EG/107/17/DOC

Proposal: Application for approval of details reserved by condition imposed under planning application EG/38/15/PL relating to condition No. 3 - Surface water drainage.

Site: 97 Barnham Road, Eastergate, PO22 0EQ.
EG/107/17/DOC

Screen Print

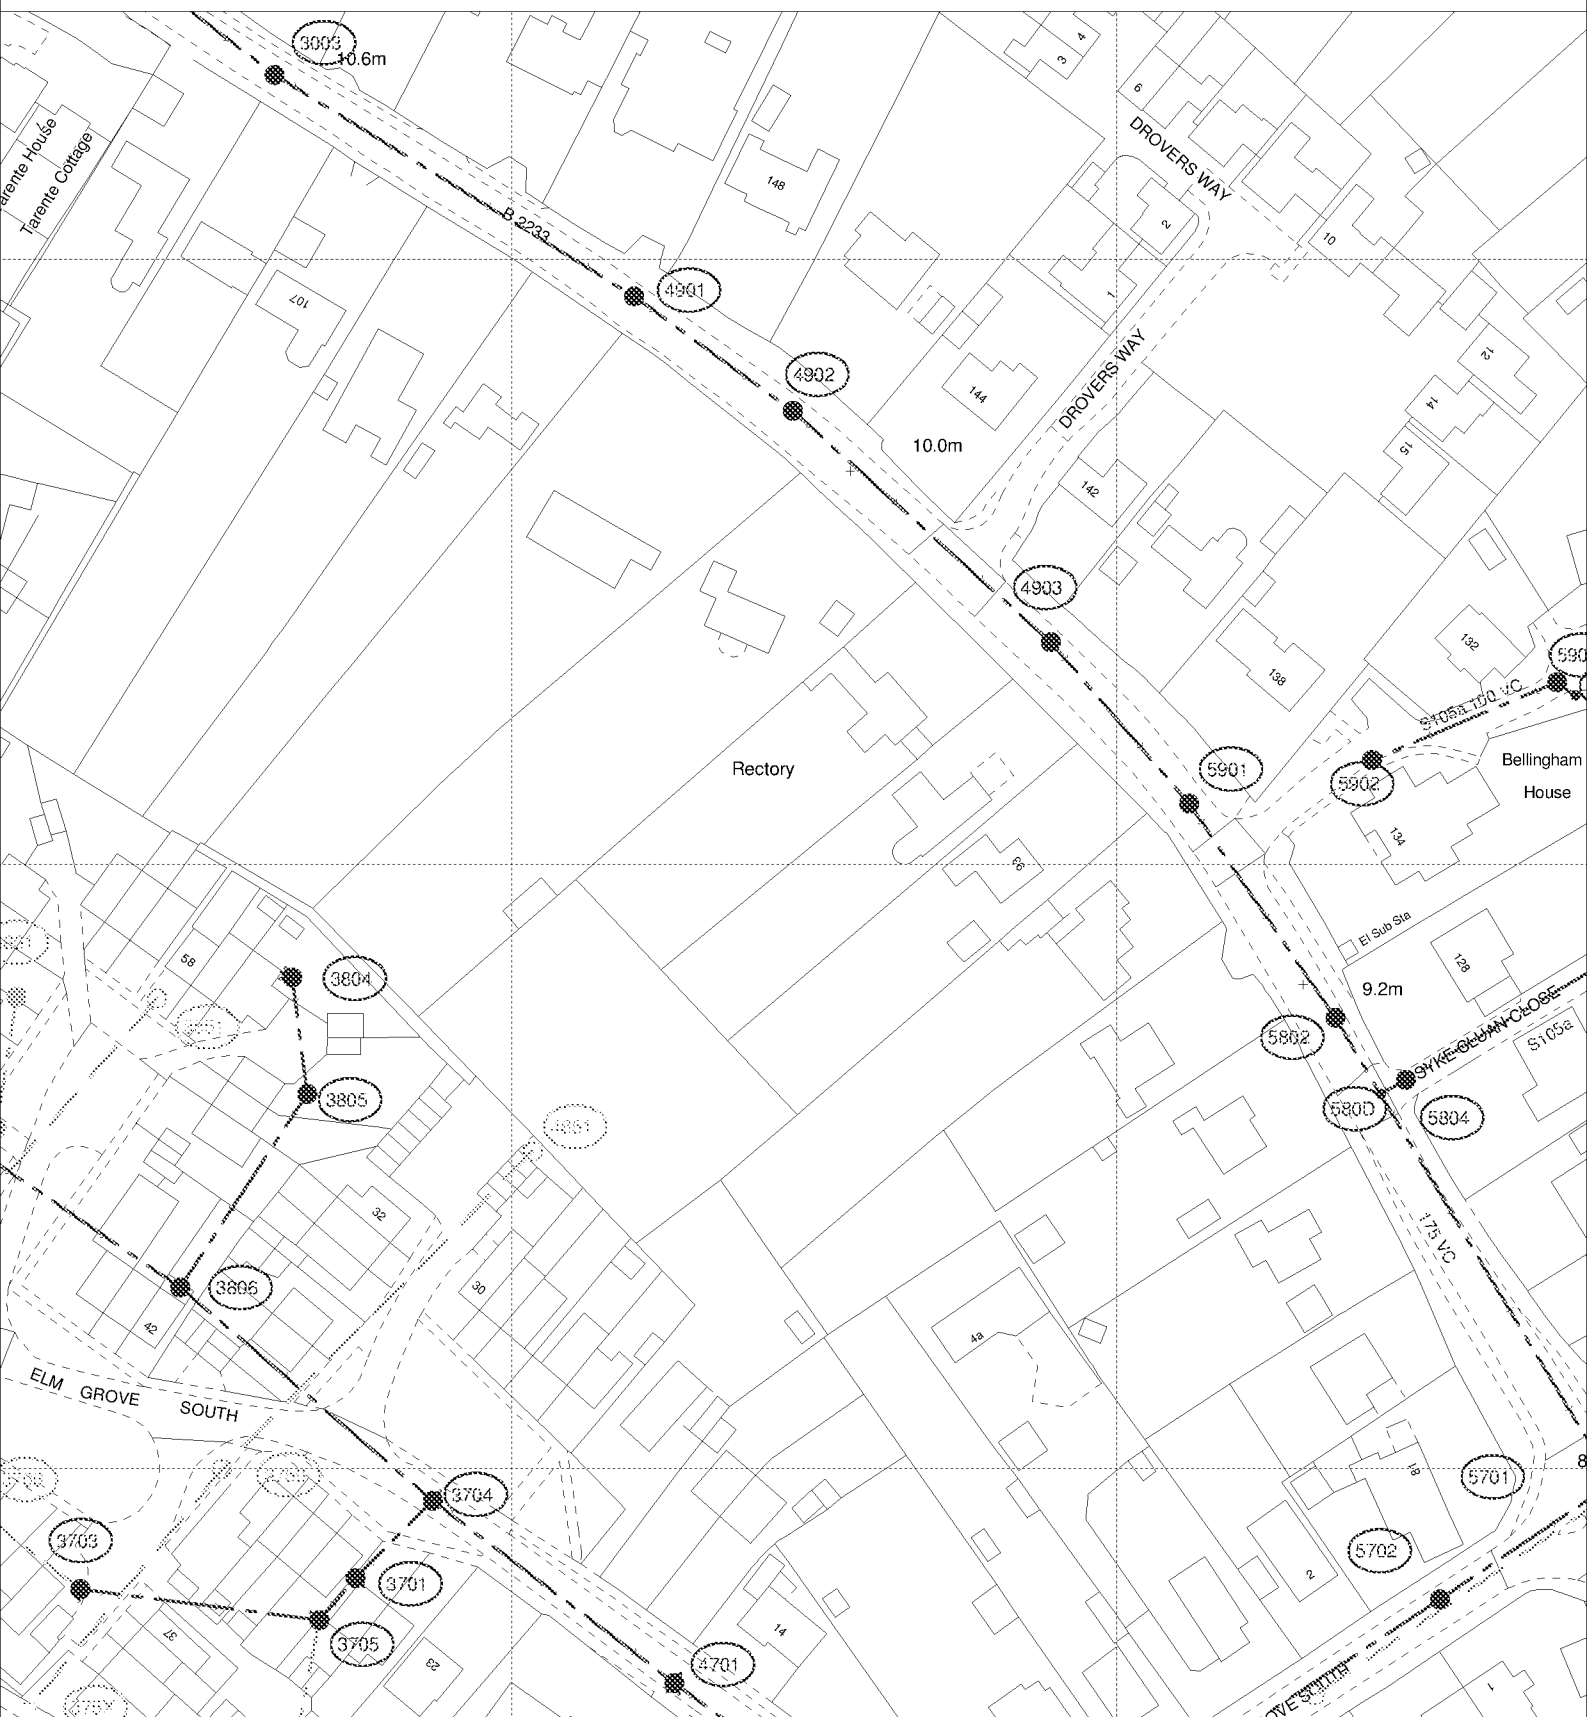
Southern Water cannot recommend discharge of condition relating to surface water drainage as the surface water connection point shown in submitted drainage layout (S17-03-01 E) is different from that as shown in Section 106 connection approval.

Also, proposed connection of surface water into foul sewer is not acceptable to Southern Water.

Please note that the surface water should not mix with the foul sewer, there are dedicated foul and surface water sewer system in the vicinity of the site. Southern Water would prefer that onsite foul and surface water discharges to the dedicated public sewer system. No surface water should be permitted to be discharged to the foul sewerage system, in order to protect properties downstream from flooding.
